Item Name: AS350/AS355 Quick Release Heli-Utility-Basket™ Long, Heavy Duty Lid

DART SERVICE INSTRUCTION

TO AMEND INSTALLATION INSTRUCTIONS D350-607-3 Rev.D,
INSTALLATION INSTRUCTIONS D350-607-4 Rev. C AND
INSTRUCTIONS FOR CONTINUED AIRWORTHINESS ICA-D350-607 REV. 6

A	NEW ISSUE	AJS	14.05.16
REV.	DESCRIPTION	BY	DATE
DESIGN	AJS	DART AEROSPACE LTD	
DRAWN	AJS	HAWKESBURY, ONTARIO, CANADA	
CHECKED		DRAWING NO.	REV. A
MFG. APPR.	N/A	DSI 9699	SHEET 1 OF 2
APPROVED		TITLE	SCALE
DE APPR.		LUG REPLACEMENT	NTS
DATE	14.05.16	COPYRIGHT © 2014 BY DART AEROSPACE LTD THIS DOCUMENT IS PRIVATE AND CONFIDENTIAL AND IS SUPPLIED ON THE EXPRESS CONDITION THAT IT IS NOT TO BE USED FOR ANY PURPOSE OR COPIED OR COMMUNICATED TO ANY OTHER PERSON WITHOUT WRITTEN PERMISSION FROM DART AEROSPACE LTD.

FIGURE 1: INSTALLATION OF D4775-041 FWD STRUT

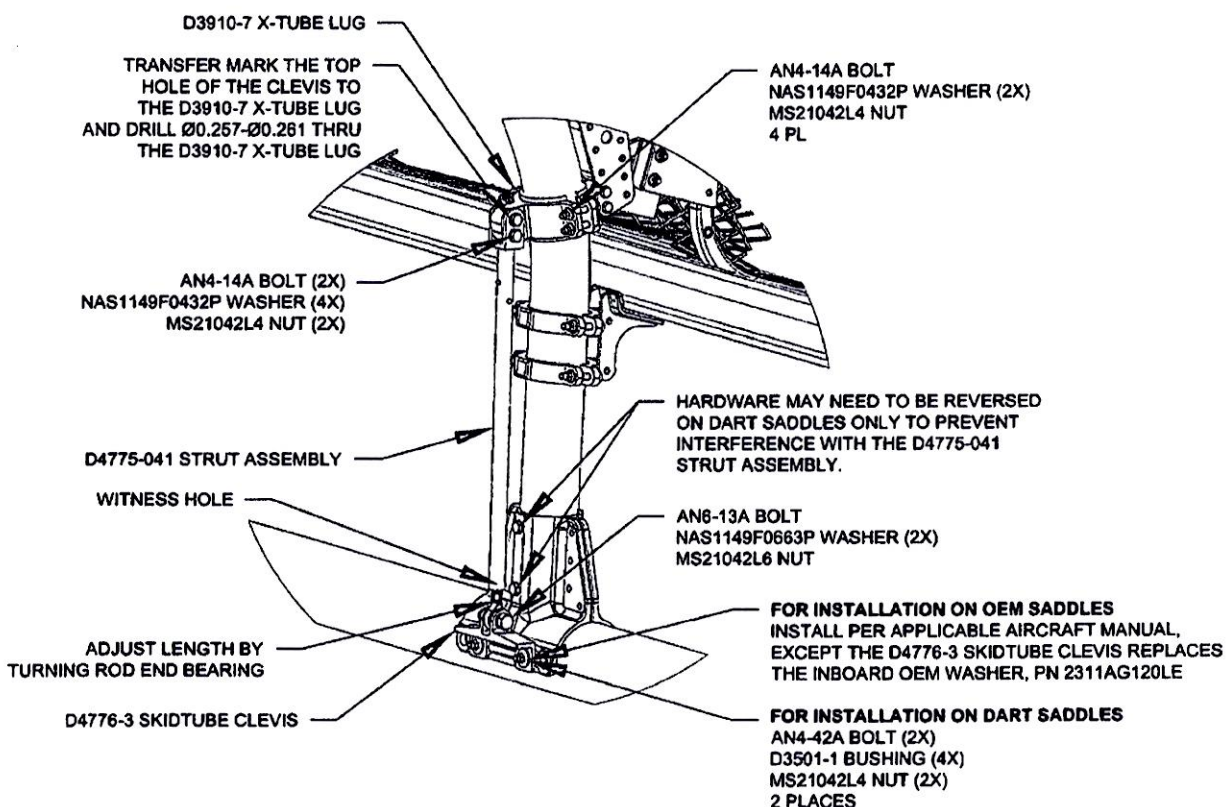
Modify the quantities for D3910-5 and add D3910-7 as follows:

- 3.1 Substitute the Forward Lower D3910-5 X-Tube Lug with the D3910-7 X-Tube Lug as shown in Figure 1.
- 3.2 Install the forward D4775-041 Strut Assembly. Transfer mark from the upper hole on the clevis of the D4775-041 Strut Assembly to the D3910-7 X-tube Lug and drill thru the lug $\varnothing 0.257$ - $\varnothing 0.261$ as shown in Figure 1. Touch up chemical conversion coating per MIL-DTL-5541. Check the witness holes located at the bottom end of the D4775-041 Strut Assemblies to ensure that the thread from the rod end extends past the witness hole.
Torque MS21042L4/-4 nuts to 50-70 in-lbs (5.7-7.9 N-m). Torque MS21042L6/-6 nuts to 160-190 in-lbs (18.1-21.5 N-m).
- 3.3 Complete the installation in accordance with Installation Instructions D350-607-3 Rev. D or D350-607-4 Rev. C.
